Client Name - Capital 38
Job No. 4677

21 Bloomsbury St

Condition 4 Update

Historic England - Point 5

Dormer Windows

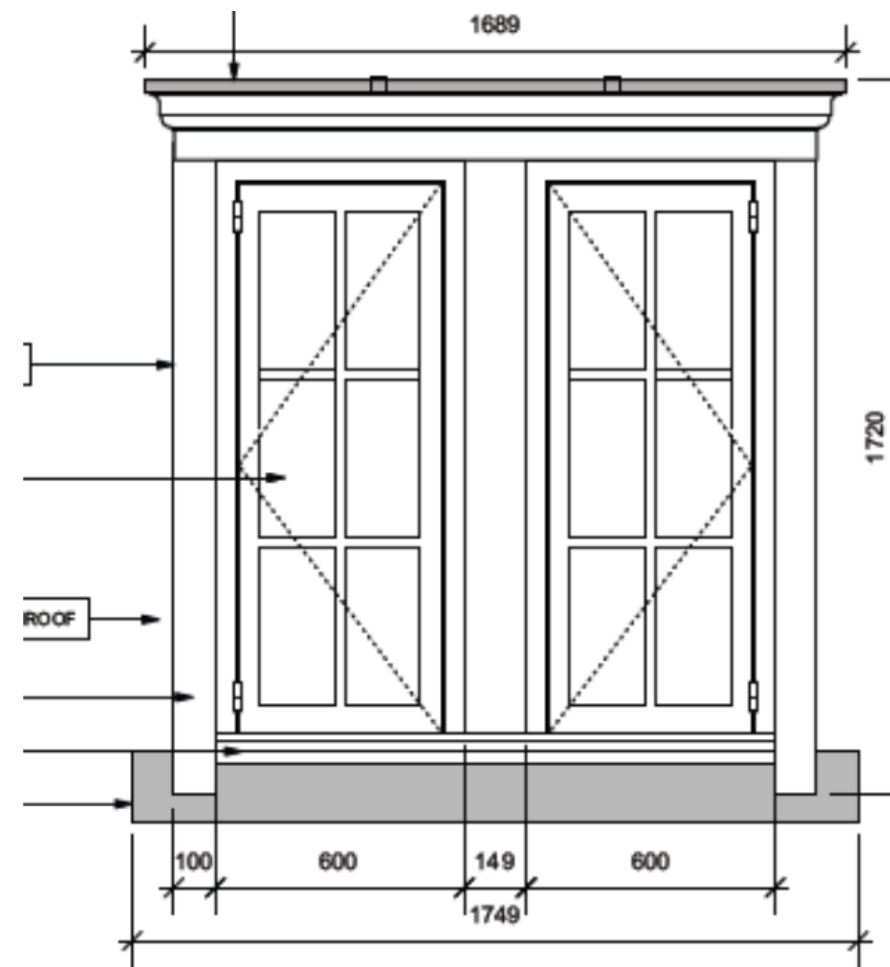
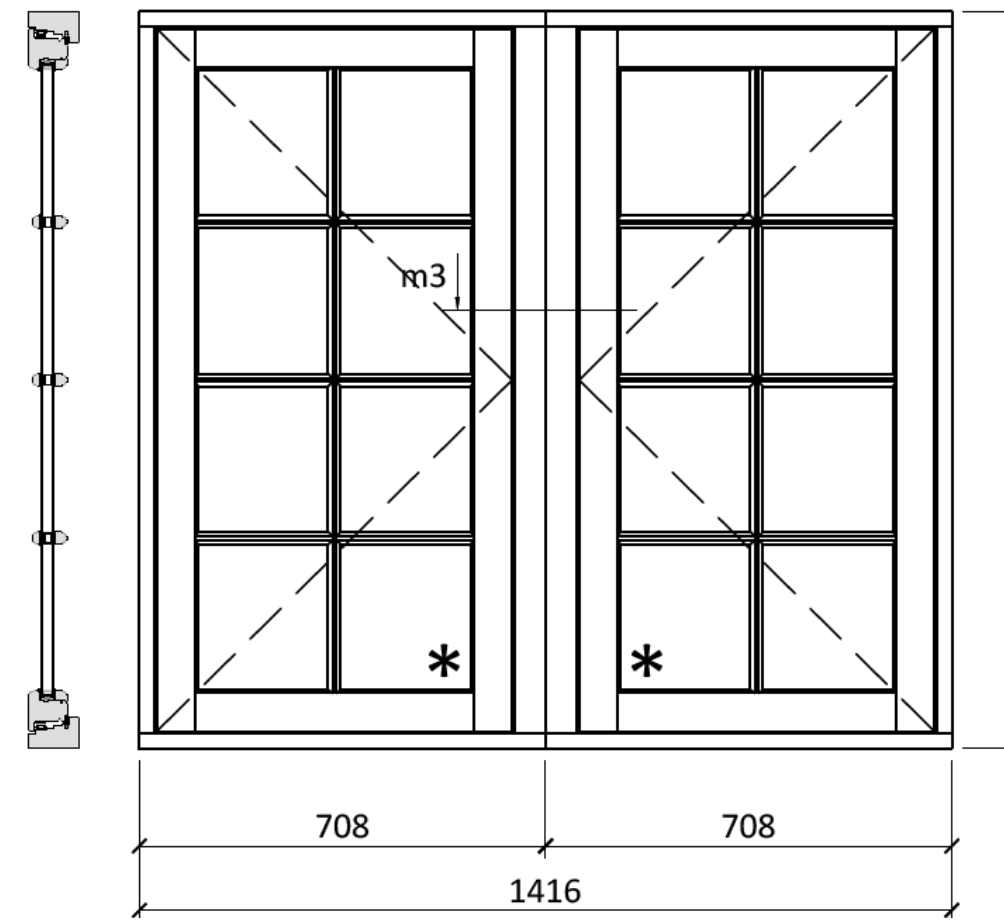
The central timber mullion details to the dormers have been reviewed and require a back to back frame for stability and robustness in their assembly. The mullion now achieves an overall thickness of 109mm when viewed from the exterior face of the building. This is in comparison to the previously submitted detail which proposed a central mullion of 149mm. With this in mind we believe we are improving the overall balance of the Dormer's aesthetic and in so doing, conforming to the latest guidance from Historic England with regard to exterior glazing.

Chimmney - Brick Specification and References

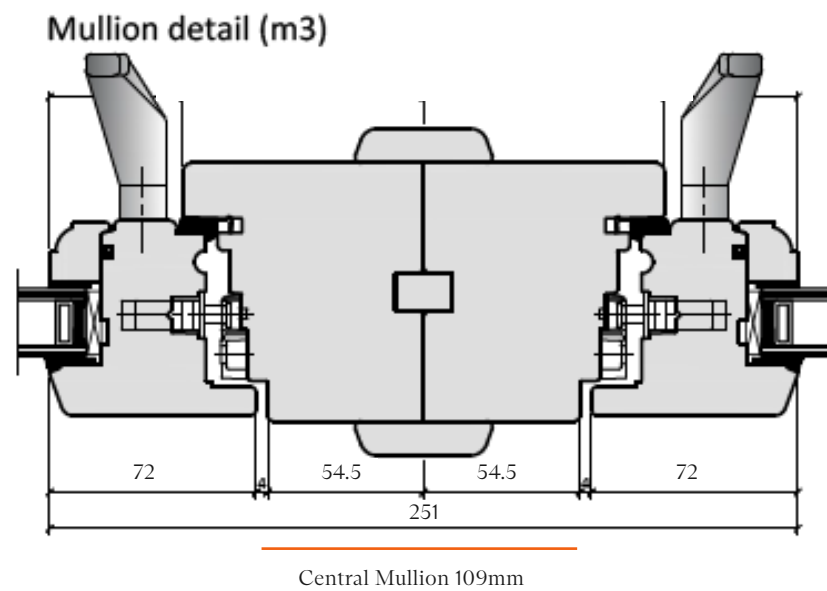
Proposed Brick to match those existing where the replacement of fibreglass chimmneys is approved
